APPLICATION FOR PERMIT TO DRILL OR REENTER

1a. Type of Work: ☐ DRILL ☐ REENTER — CONFIDENTIAL	5. Lease Serial No. NMLC068545
	6. If Indian, Allottee or Tribe Name
	7. If Unit or CA Agreement, Name and No
1b. Type of Well: ☒ Oil Well ☐ Gas Well ☐ Other ☒ Single Zone ☐ Multiple Zone	8. Lease Name and Well No. PLU PIERCE CANYON 7 FEDERAL 1H 37643

SUNDRY NOTICES AND REPORTS ON WELLS

CHANGE TO ORIGINAL APD FILED ON 11/13/2008.

WELL LOCATION AND ACREAGE DEDICATION PLAT

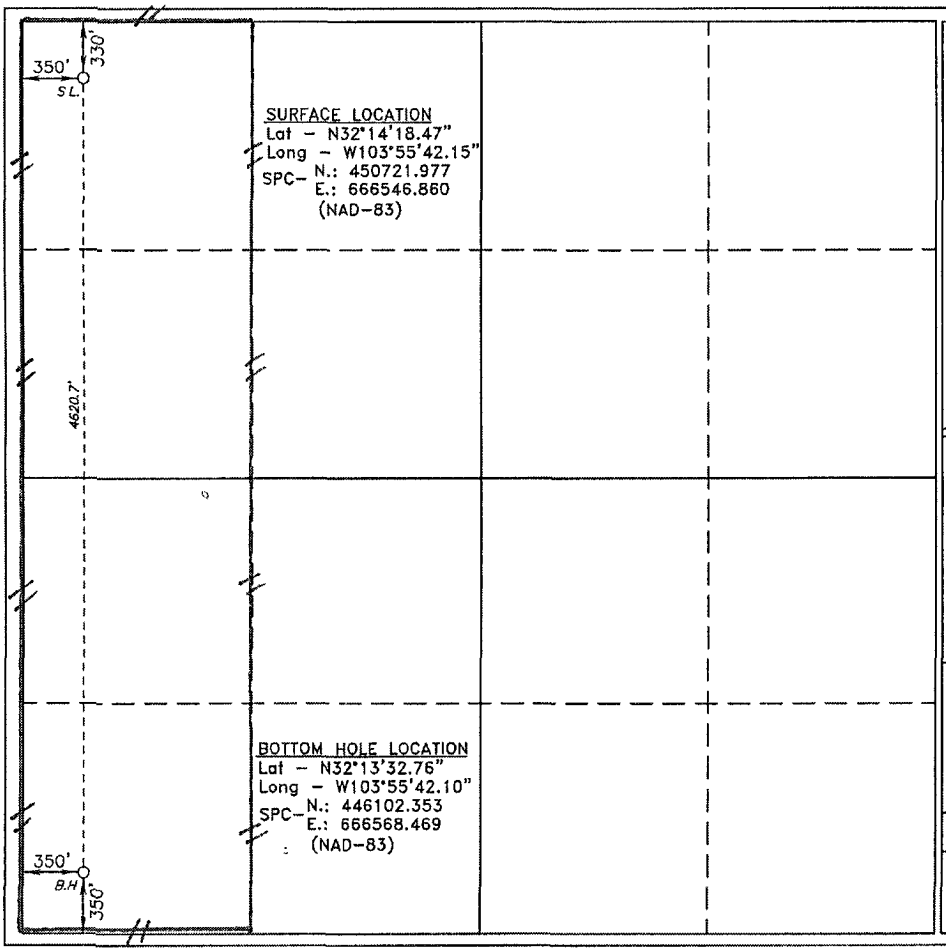
PER THE BLM AND CONTRACT ARCHAEOLOGIST THE SURFACE LOCATION HAS CHANGED FROM 200 FSL & 350 FWL, SWSW TO 330 FNL & 350 FWL, NWNW. THE BHLOC HAS CHANGED FROM 350 FNL & 350 FWL, NWNW TO 350 FSL & 350 FWL, SWSW.
